## Development Review Division

**DATE:** Feb. 26, 2021

**SUBJECT:** SP20-131 Site Plan – Planning Review 1

**LOT 6 PARKER AND PINE FILING 1**  
 PARKER, CO  
 EVERBROOK ACADEMY SITE PLAN  
 SITE PLAN

LOT 6 PARKER AND PINE FILING 1  
 PARKER, CO  
 EVERBROOK ACADEMY SITE PLAN  
 ARCHITECTURAL ELEVATIONS

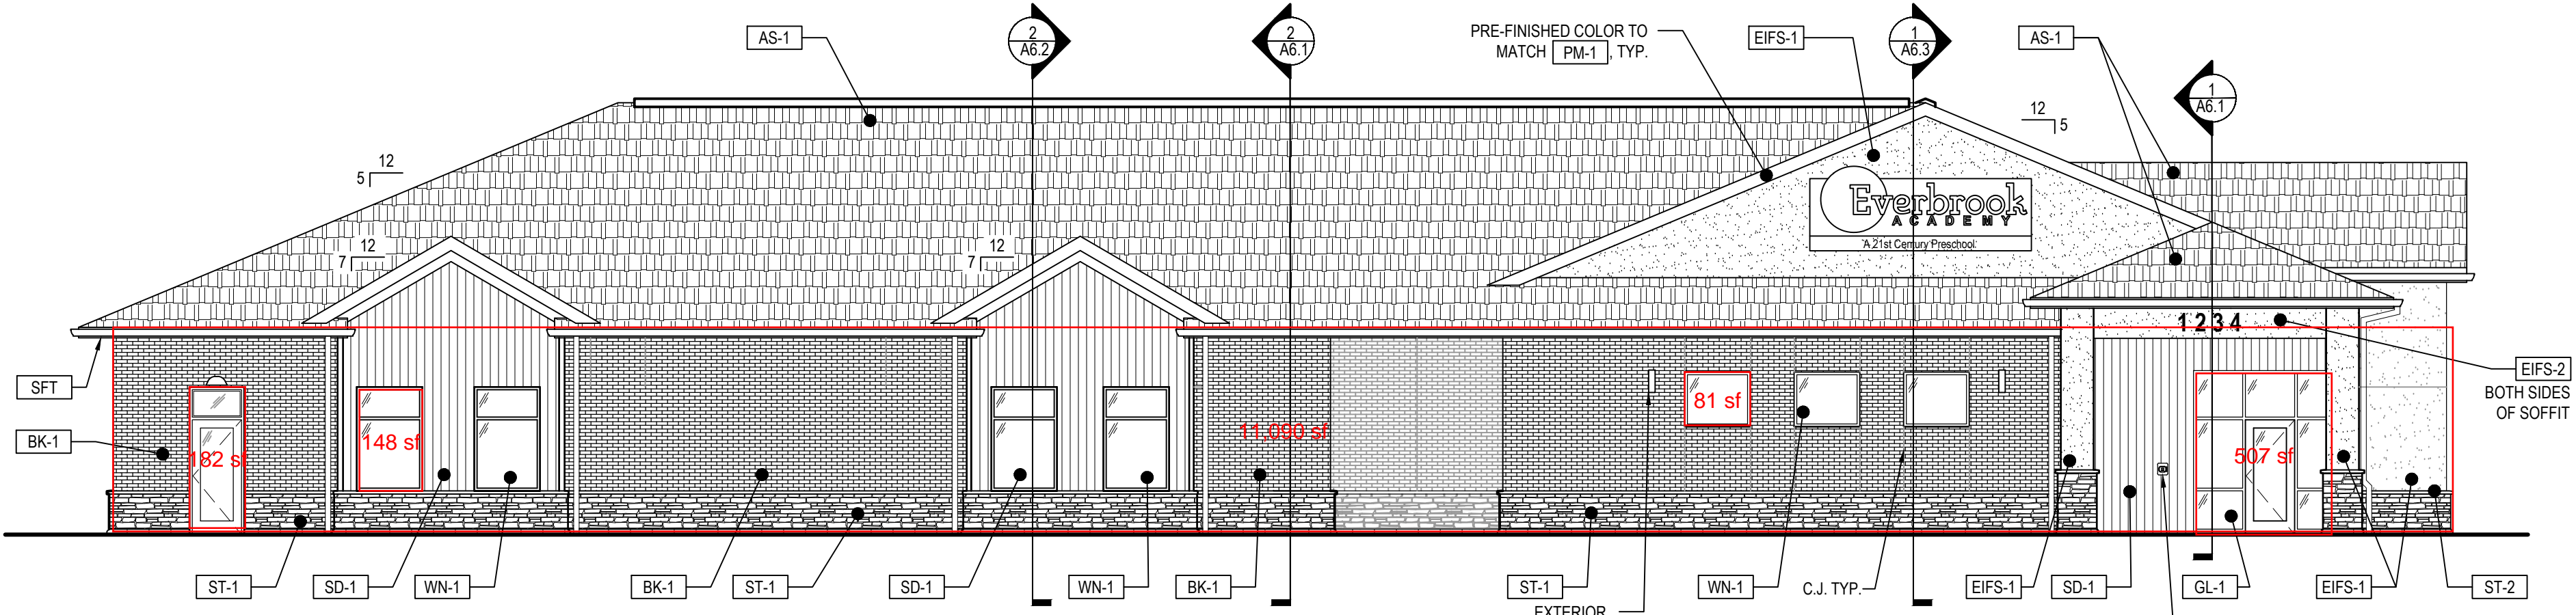
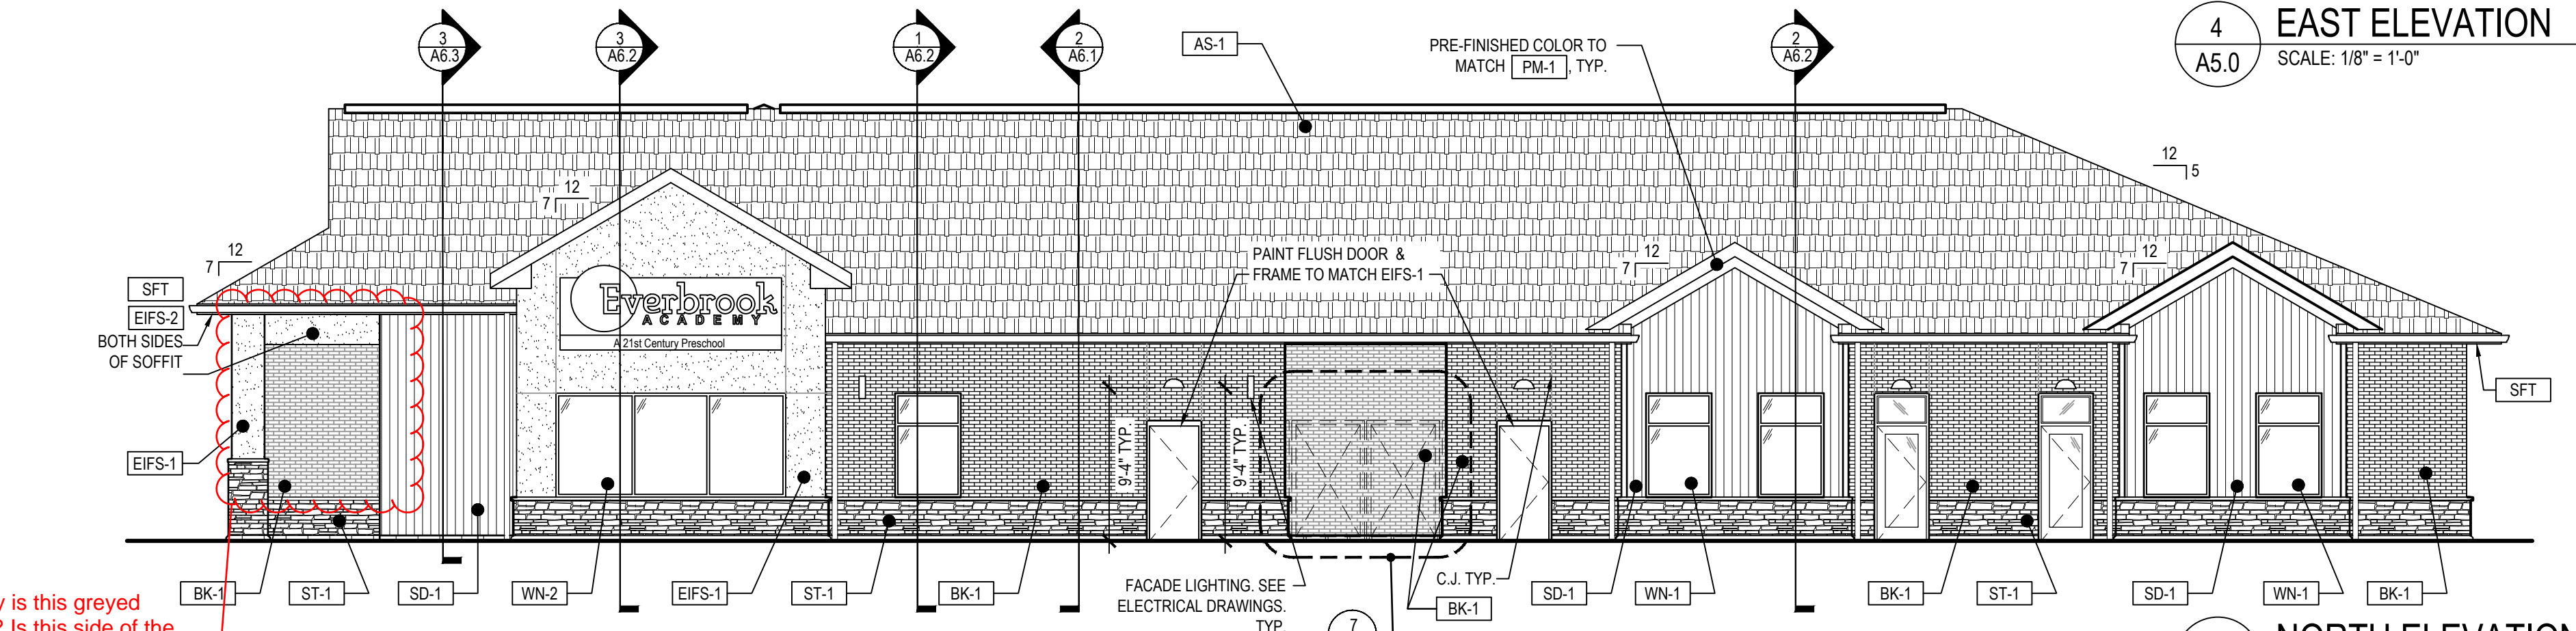
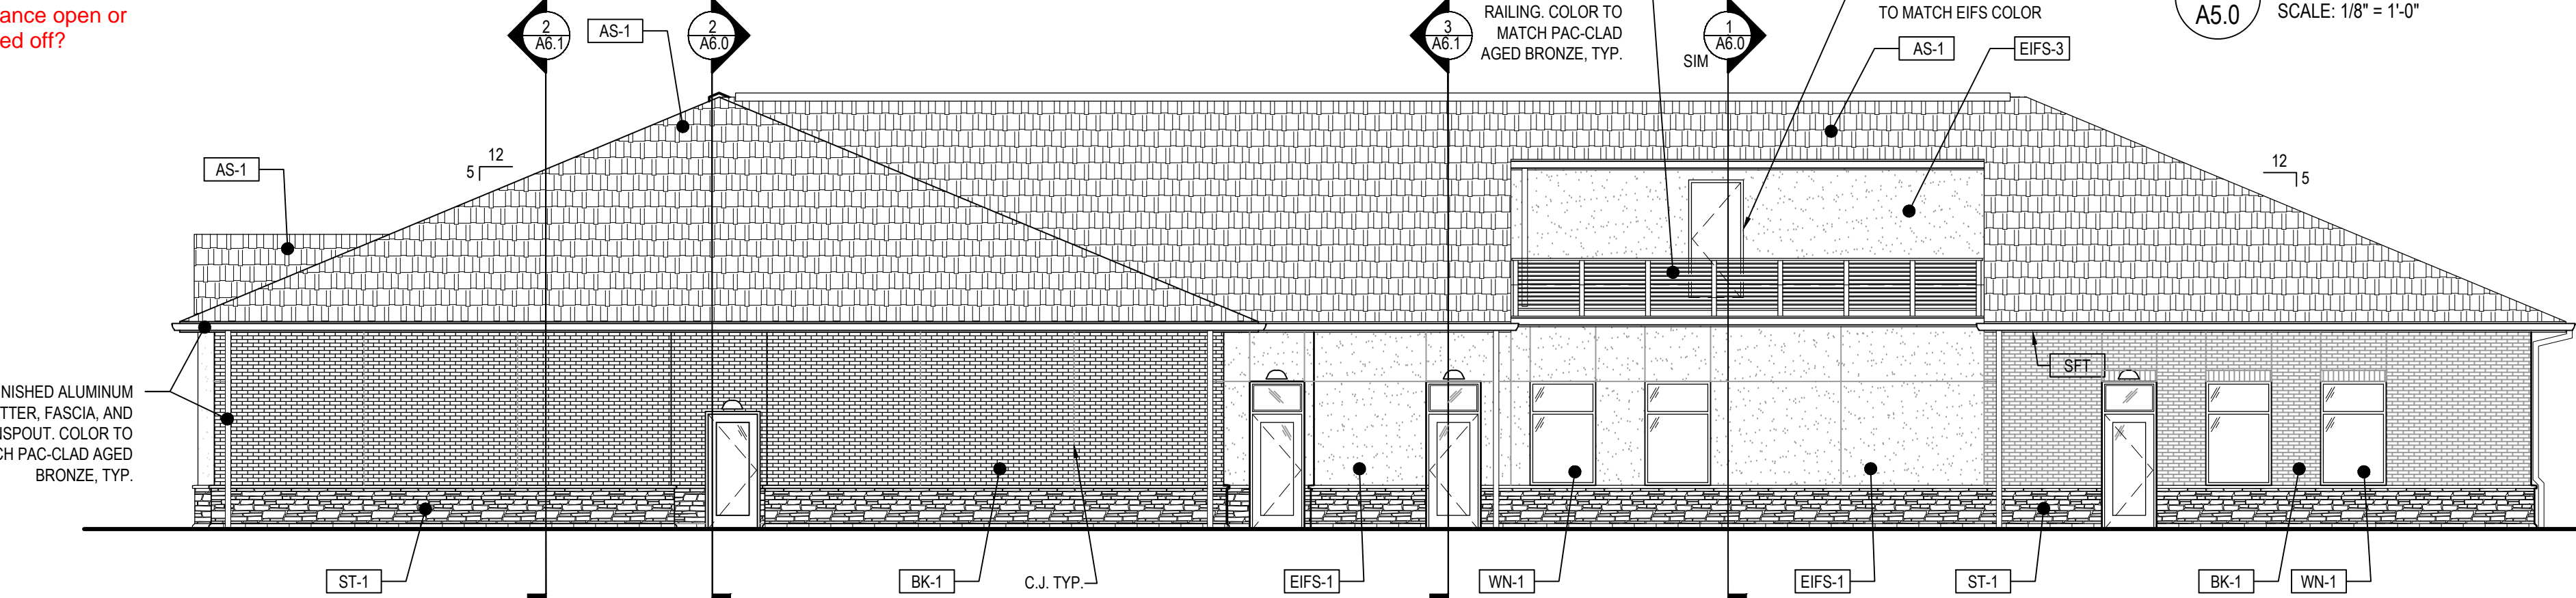
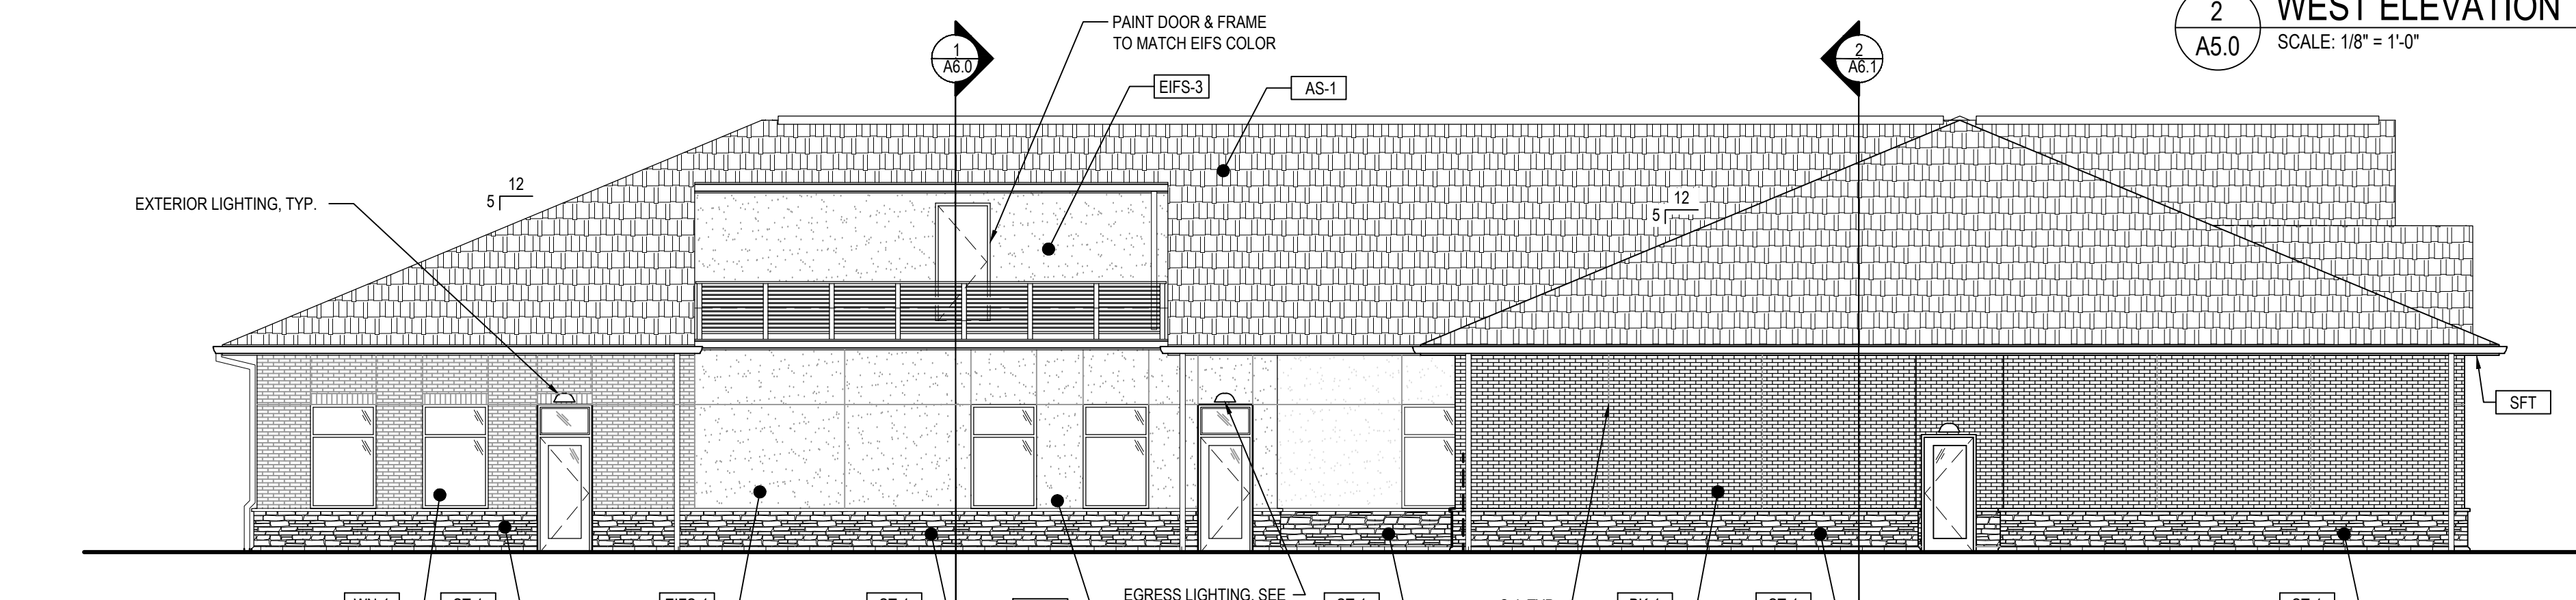
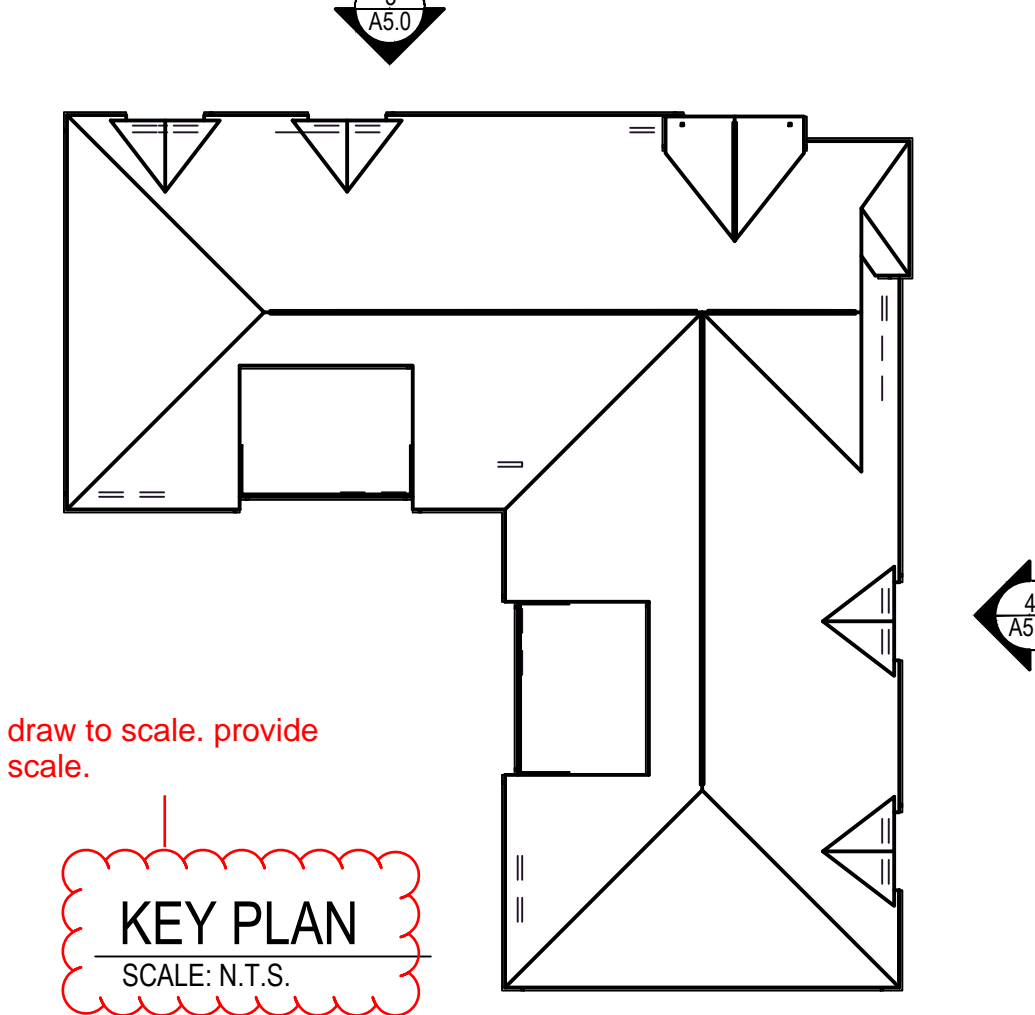
Why is this greyed out? Is this side of the facade at the entrance open or walled off?

Please check your numbers. With rough measurements I got 1524sf of glazing and 11,090 sf of facade. That's 13.7% transparency. I will measure again when drawing is to scale.

Need to hit 30%

Need 25%

Add row for required transparency.

Add row for total area of each facade.

LOT 6 PARKER AND PINE FILING 1  
 PARKER, CO  
 EVERBROOK ACADEMY SITE PLAN  
 ARCHITECTURAL MATERIALS BOARD

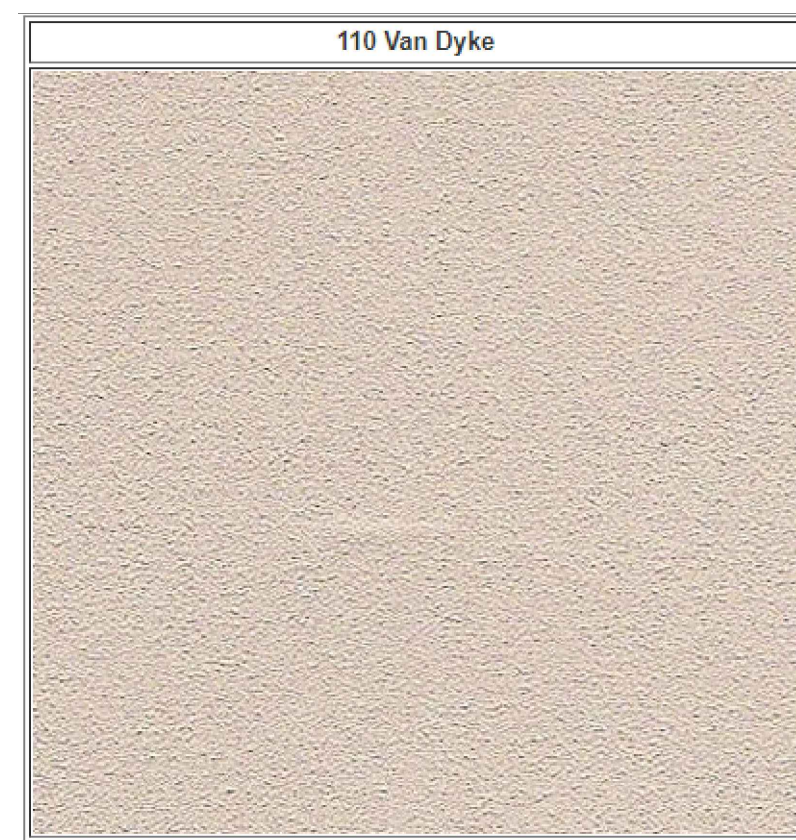
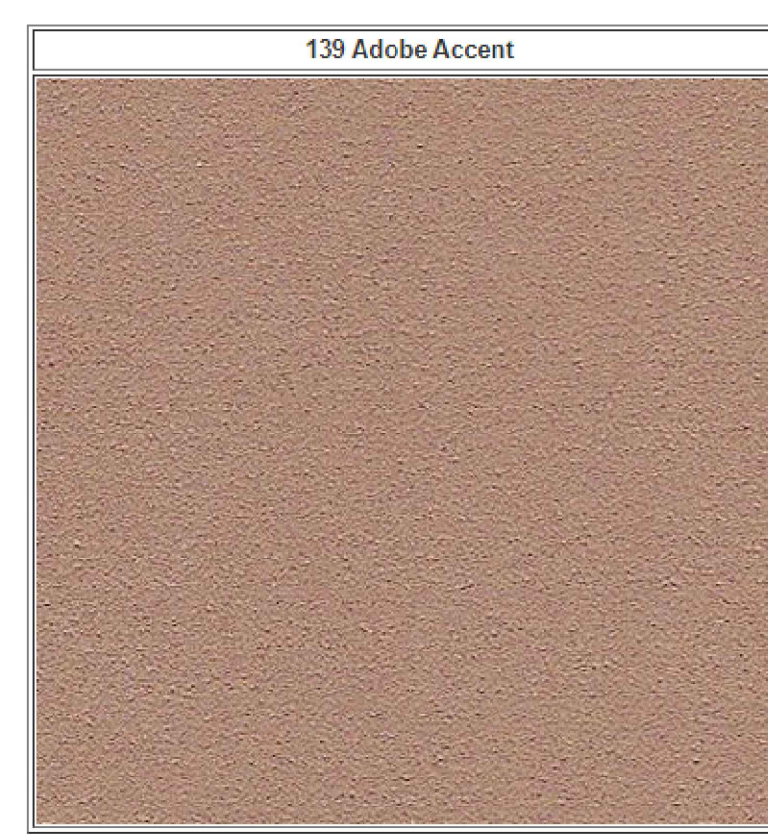
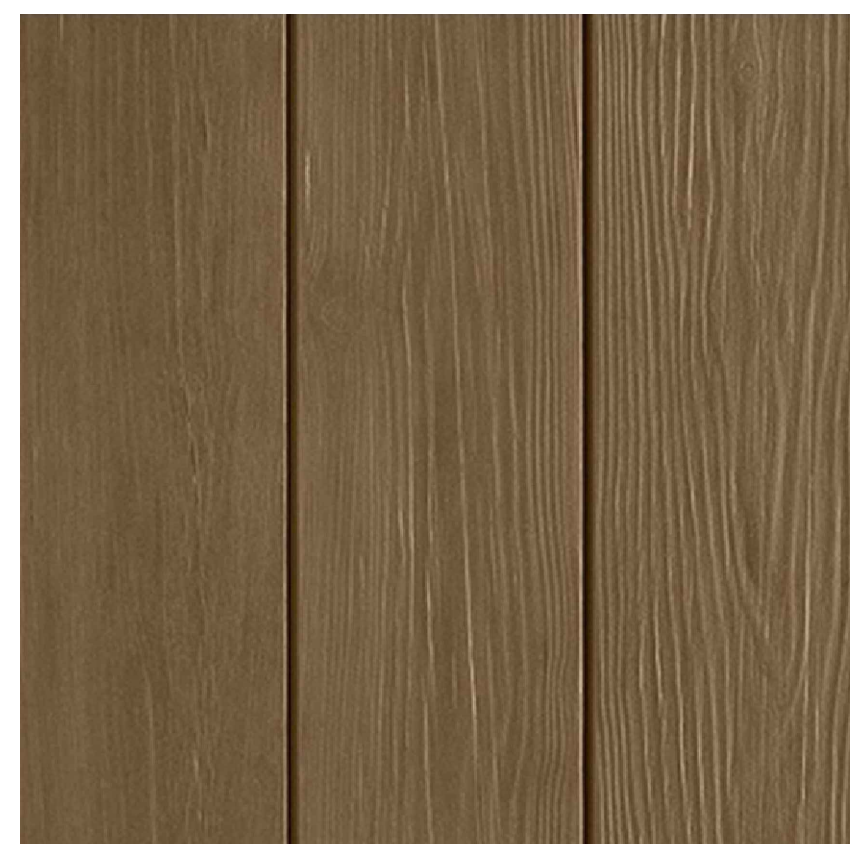
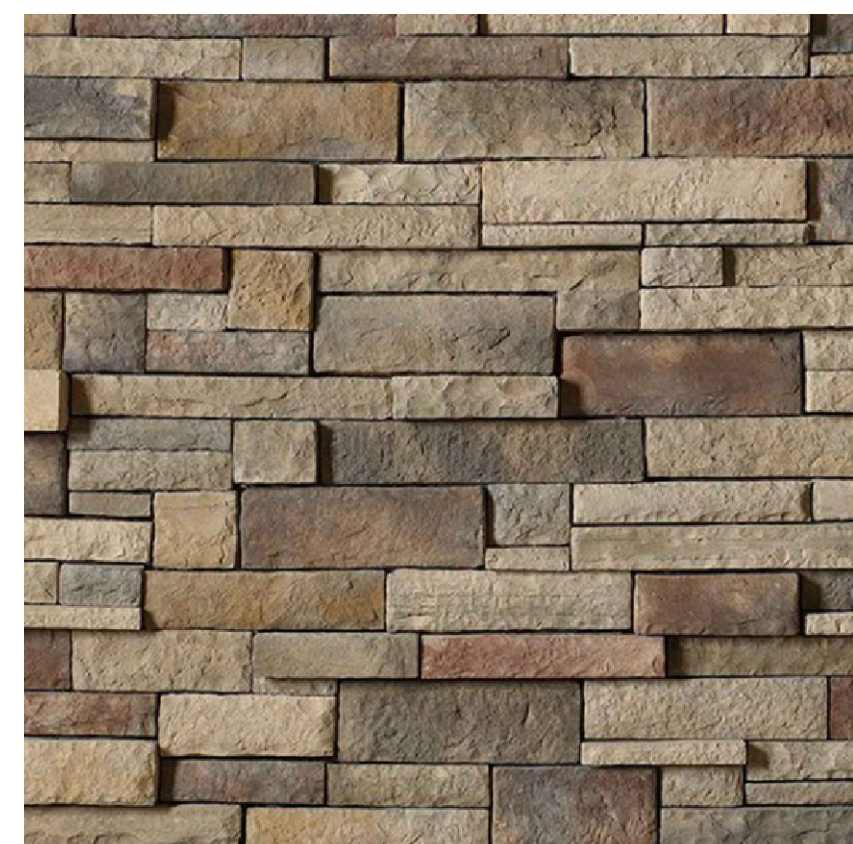
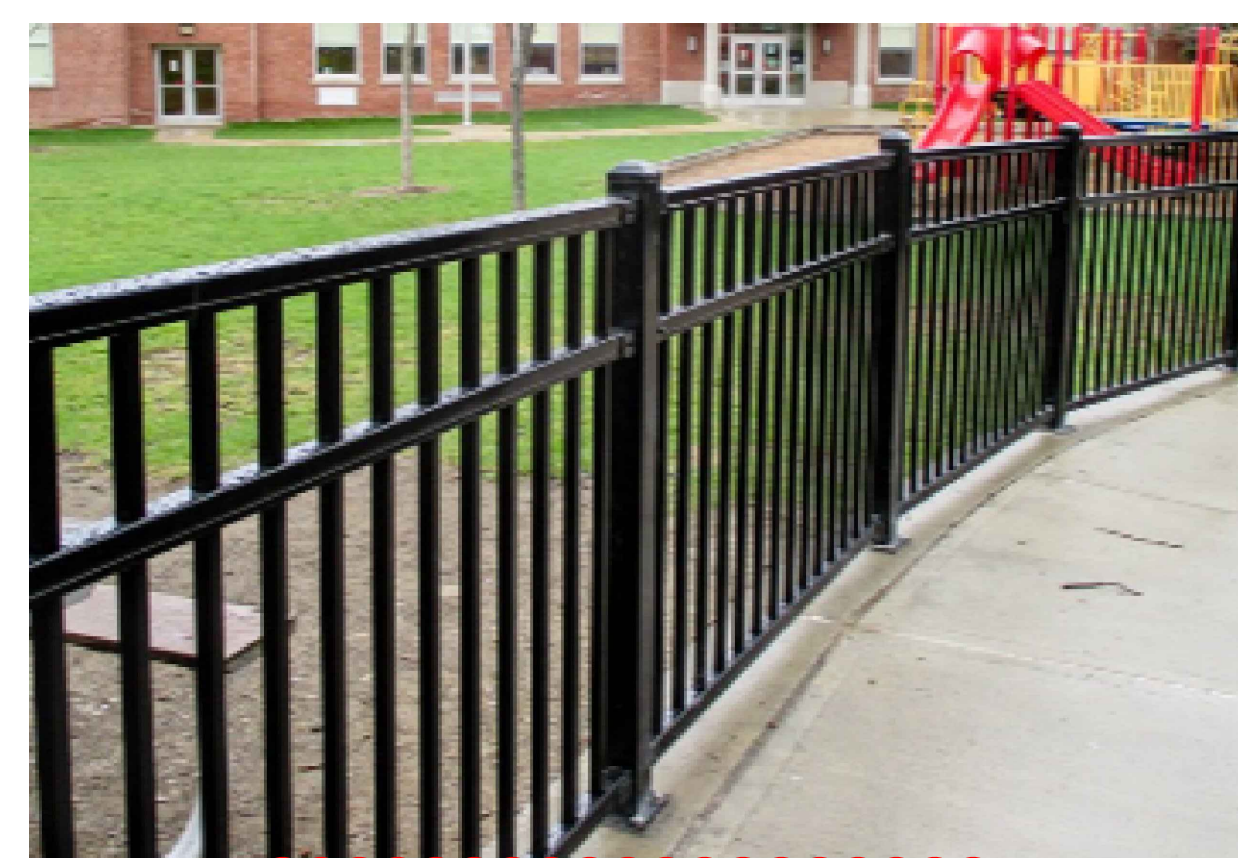
Provide materials and elevations for your retaining wall.

Provide frame material and color.

Window frames must be black or grey metal according to the design guidelines of the Parker and Pine PD

Height of fence? provide elevations

Show swatch and call out material of door and window frames. Must be black or grey metal.
